REVISED RESPONSE TO REQUEST FOR ADDITIONAL INFORMATION

APR1400 Design Certification

Docket No. 52-046

RAI No.: 255-8285
SRP Section: 03.08.05 - Foundations
Application Section: 03.08.05
Date of RAI Issue: 10/19/2015

Figure 1 Typical Detail for Installation of Waterproofing Membrane

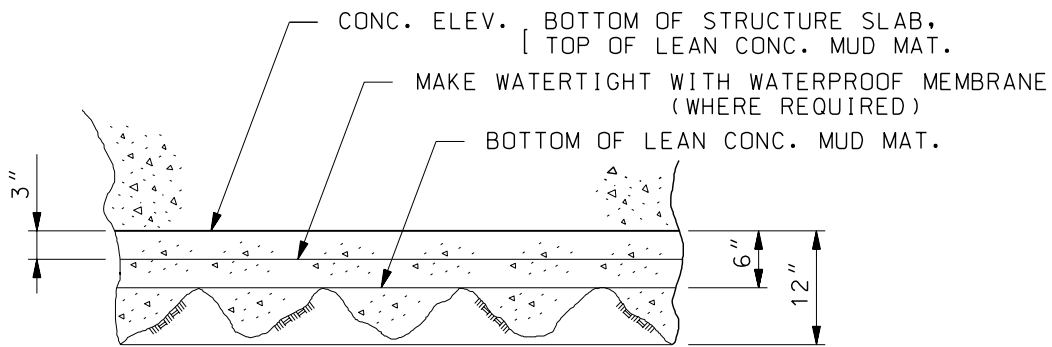
Applicant is requested to describe, whether waterproofing membranes are used in APR1400 design, and if used, provide effects on the shear resistance of the NI common basemat.

A typical detail for installation of the waterproofing membranes is shown in Figure 1. Because the membranes are installed between lower and upper lean concrete beneath the basemat, they affect the shear resistance of the NI common basemat.

The sliding by shear transfer may be considered across the interfaces between dissimilar materials, i.e., foundation concrete on lean concrete, lean concrete and waterproofing membrane, lean concrete and the supporting medium (soil or rock), and within the supporting medium.

The coefficient of friction between the lean concrete and waterproofing membrane is bounded by 0.55 as described in COL 3.8(13). This value is compared with the coefficients of friction between other interfaces, and the minimum value among them is used for stability check of the basemat.

Figure 1 Factor of Safety against Sliding at Each Time Step

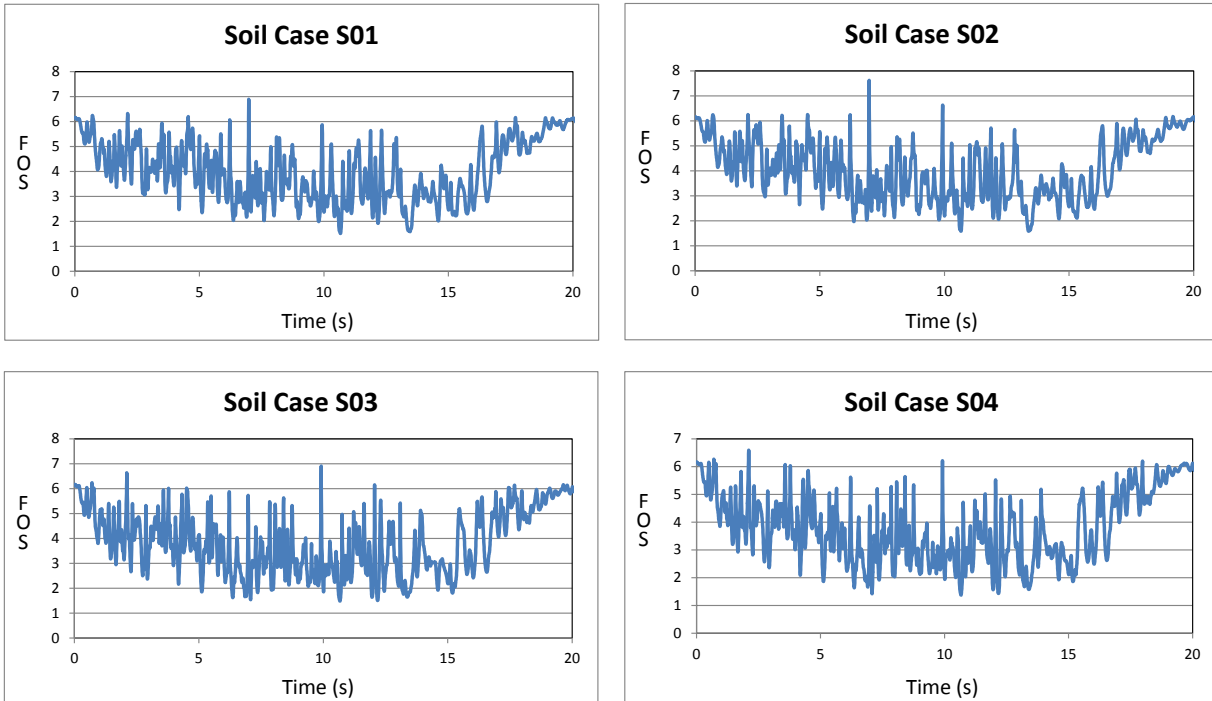
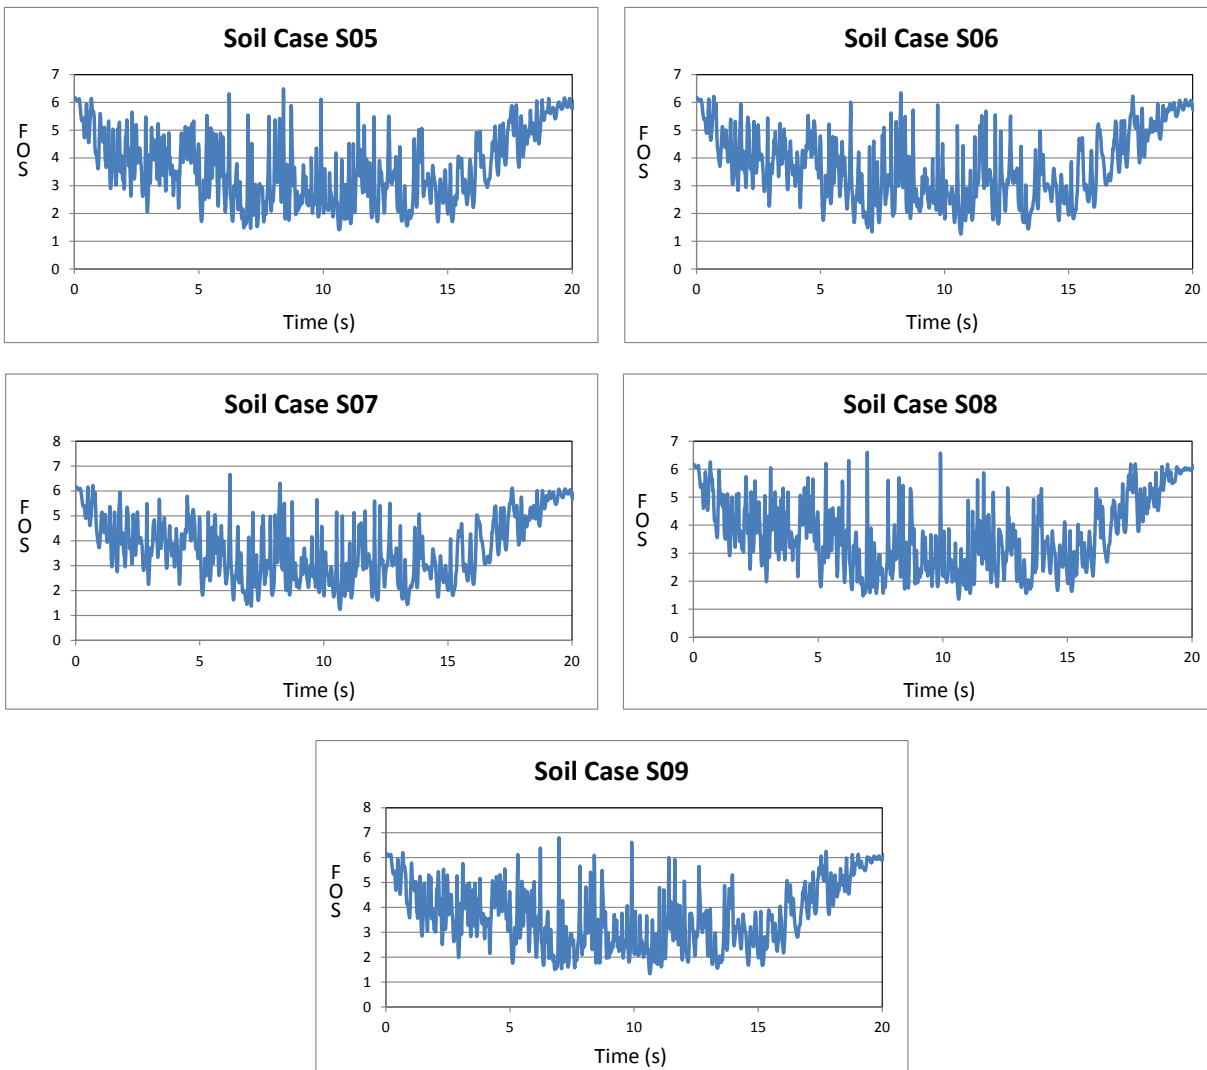
Technical Report (TR) APR1400-E-S-NR-14006-P, Rev. 1, "Stability Check for NI Common Basemat," Section 4.2.2, "Sliding Check," states that, "The resistance forces against sliding of the common basemat are checked for the driving shear forces generated for the seismic load. The basemat friction force is considered to resist the sliding of the common basemat." The applicant further stated that coefficient of friction for sliding check is 0.7. The applicant's approach for evaluating the sliding analyses of the Category I structures is not clear to the staff. SRP 3.8.5 II.4.G and B provides the criteria for determining the sliding forces and overturning moment of the Category I structures subject to seismic loads. Per 10 CFR 50.55a; Appendix A to 10 CFR Part 50, General Design Criteria 1, 2, 4, 16 and 50; and SRP 3.8.5, the applicant is requested to provide a detail description of the method used to determine the sliding check of the Category I structures; and to justify that the coefficient of friction of 0.7 represents the minimum coefficient of friction considering the various sliding interfaces including concrete to soil, waterproofing to soil, and concrete basemat to concrete mudmat.

The factor of safety (FOS) against sliding is calculated at each time step ($t = 0 \sim 20.48$ seconds with an interval of 0.005 seconds) for each soil case (S01 ~ S09; S10 is a fixed base case), i.e., by linear time history method. The final result is shown in Table 1 and Figure 1 below.

Finally, the minimum FOS against sliding during the entire time period and for all soil cases is obtained as 1.25, as shown in Table 1.
